# HISTORIC DISTRICT COMMISSION NOTICE OF DENIAL

#### Application Number: HDC2025-00291

|  |                                    | • •  |   |                                       |
|--|------------------------------------|--|---|---------------------------------------|
| PROJECT ADDRESS: 1068 Hubbard Street   |                                    |  |   |                                       |
| HISTORIC DISTRICT: Hubbard Farms   |                                    |  |   |                                       |

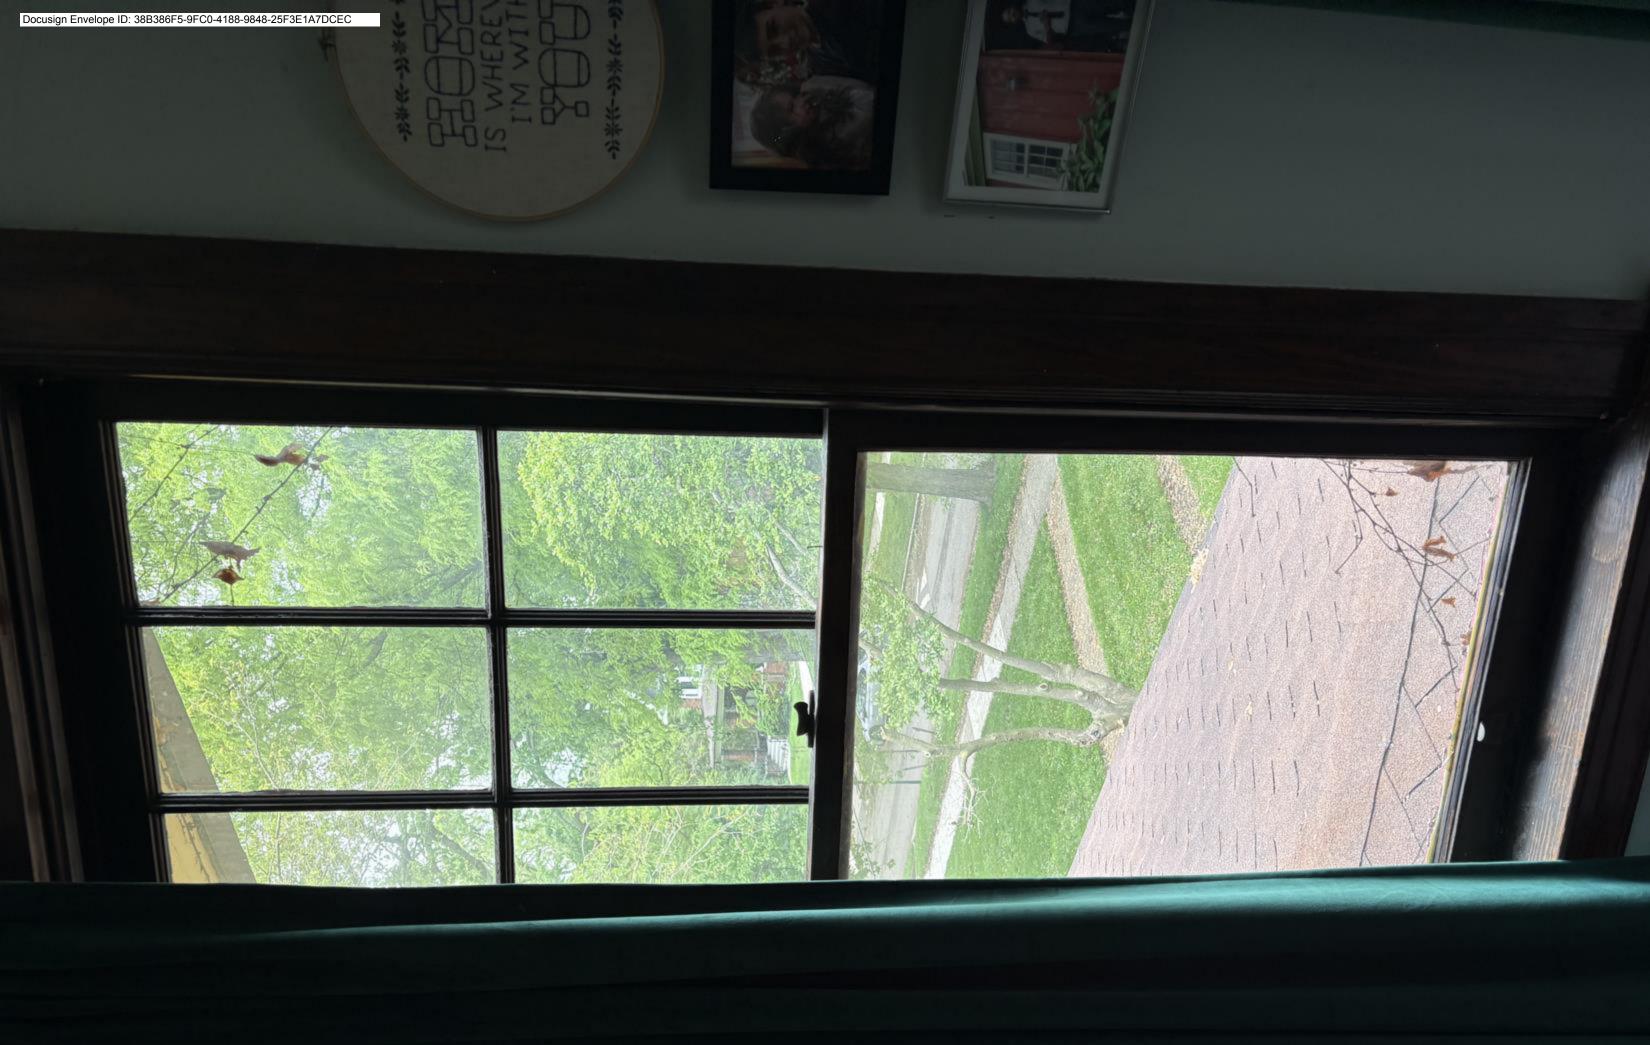
Exterior photographs of each side of the house, showing the location/relationship of all window openings (including the rear windows that you mention were previously replaced). Please number the individual windows proposed for replacement to match the line numbers on the window replacement order.

Please submit additional interior photographs showing the deteriorated areas of the windows (such as the stated gaps in the trim; most of the interior photographs are dark so staff can't see the window frames).

The windows appear to be intact and repairable; please explain if you obtained, or attempted to obtain, a repair estimate.

Thank you for the response. I have attached pictures of the third floor renovation of windows which was done and approved through the commission in 2017. This replaced all of the third floor windows with new windows. I have included a document that numbers the windows in relation to how they are listed in order on the material sheet. I have also attached some photos of the condition of the existing windows. There are cracks in the glass, chipped bottoms of the windows, missing ropes in the pulleys and, though this cannot be conveyed in photos, 25% of the windows are sealed in some manner and do not open. I cannot include exterior pictures of the two side windows due to the proximity of my neighbor's homes. It is not possible for me to get enough distance to take a picture of the second floor without being in their homes. Consequently, the pictures of the two side second floor windows are from the interior.
